# METROPOLITAN GOVERNMENT OF NASHVILLE AND DAVIDSON COUNTY

## STAFF RECOMMENDATION 2601 Belmont Boulevard August 21, 2013

**Application:** New construction—outbuilding; Setback reduction  
**District:** Belmont-Hillsboro Neighborhood Conservation Zoning Overlay  
**Council District:** 18  
**Map and Parcel Number:** 11704010100  
**Applicant:** Manuel Zeitlin  
**Project Lead:** Melissa Baldock, melissa.baldock@nashville.gov

**Description of Project:** Application is to construct a new outbuilding that requires a setback reduction. A skyway connector is proposed to link the second story of the house with the second story of the garage. The proposal is a revision to the proposal presented at the July regularly scheduled hearing.

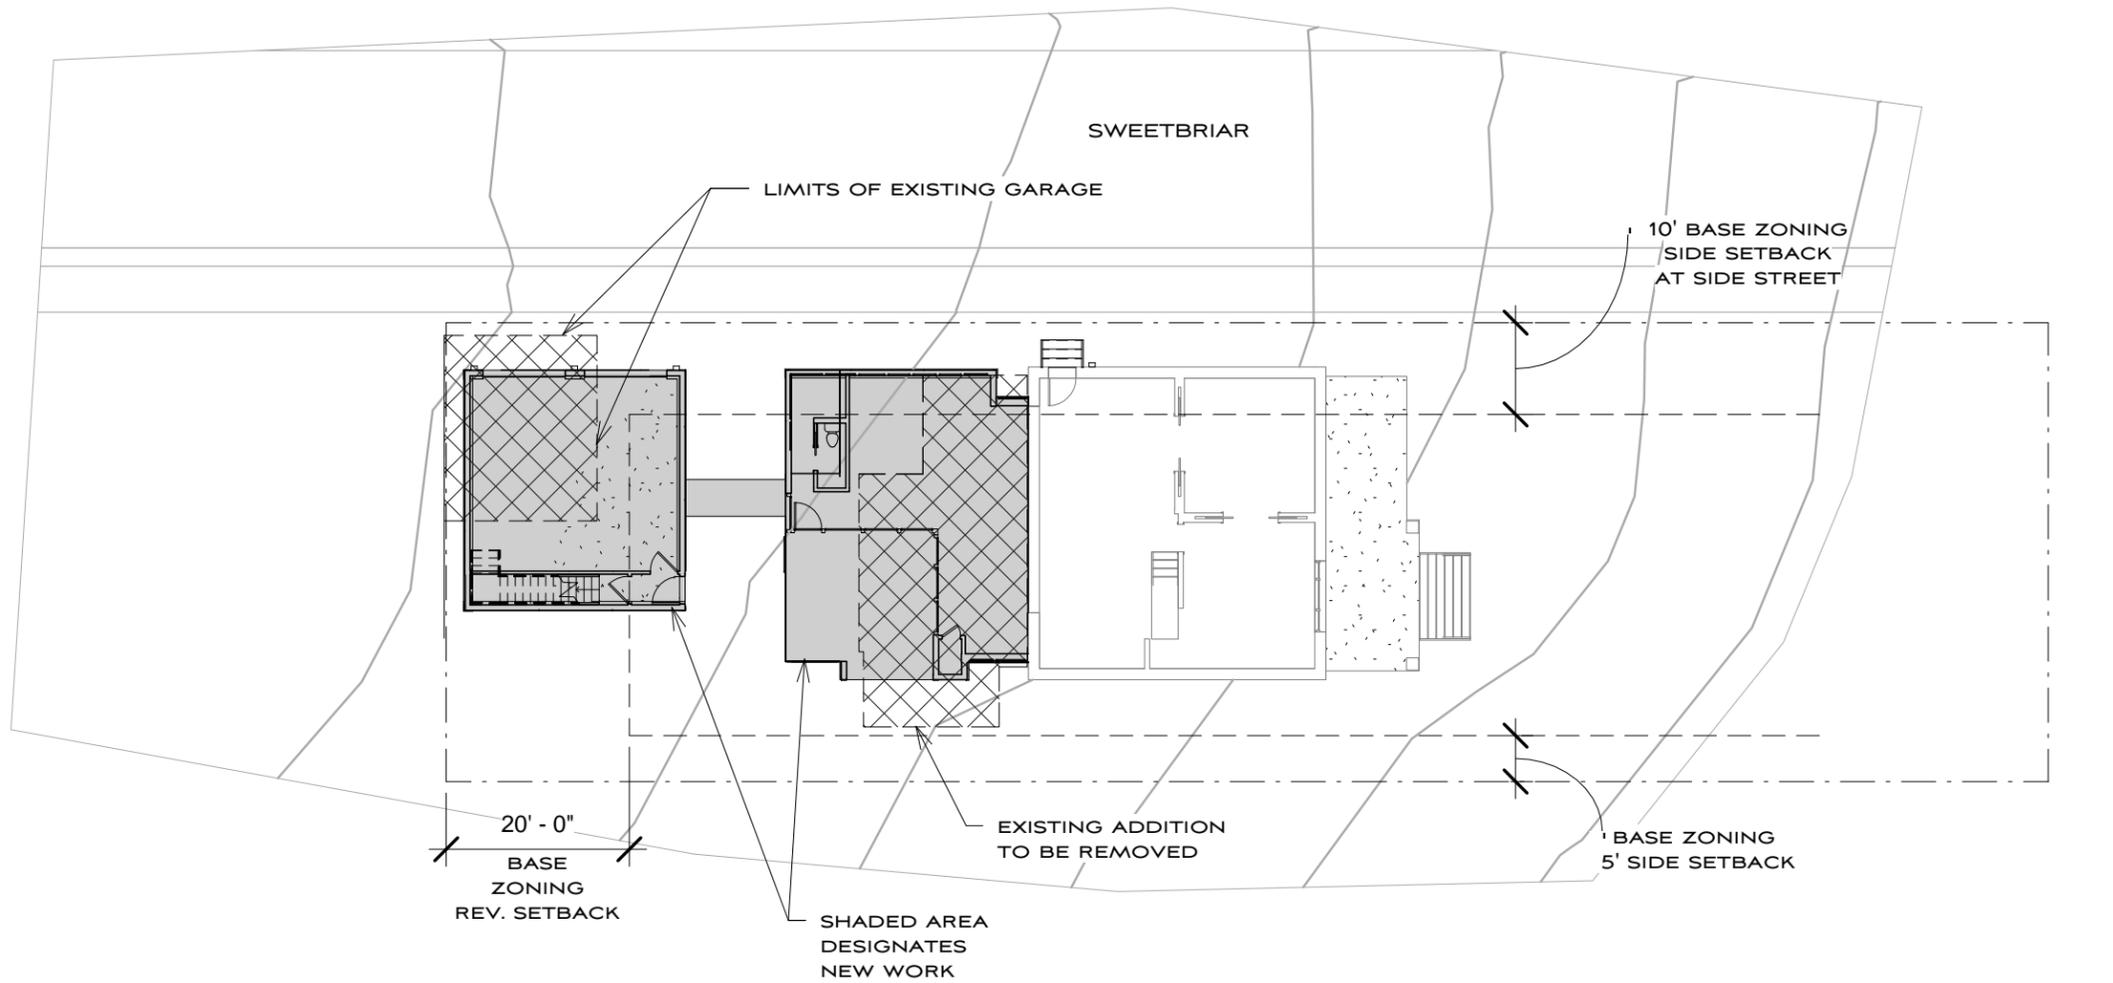
Character: A second story skyway connector is proposed to connect the primary structure to the outbuilding. The skyway connector is four feet (4') wide and eleven feet, two inches (11'2") long. The bottom of the skyway connector will be approximately fourteen feet, nine inches (14'9") above the grade and the top of the skyway's rail will be just under eighteen feet (18') above the grade. The design guidelines require that outbuildings should "reflect the character of the period of the house" and should be

compatible with surrounding historic outbuildings. There are no instances of buildings in the district being connected by skyways. Staff recommends disapproval of this feature.

The second story skyway connecting the house to the garage is not something that was seen historically and is not something the Commission has approved in the past in this district. When the Commission has approved connectors between a house and an outbuilding, the connections have been made on the ground floor and have appeared to be landscape features like a small pavilion or pergola. This connector will in essence create a two-story attachment to a two-story garage. The design guidelines state that attached garages are only appropriate when the vehicular entry is at the basement level and the garage doors are on the rear. The proposed garage does not meet either of those criteria. Moreover, because the site is a corner lot, the connector will be highly visible, and will be out of character for the district.

1. The skyway connector be eliminated.
2. Staff review and approve the door materials and specifications.
3. The lap siding have maximum reveal of five inches (5”).
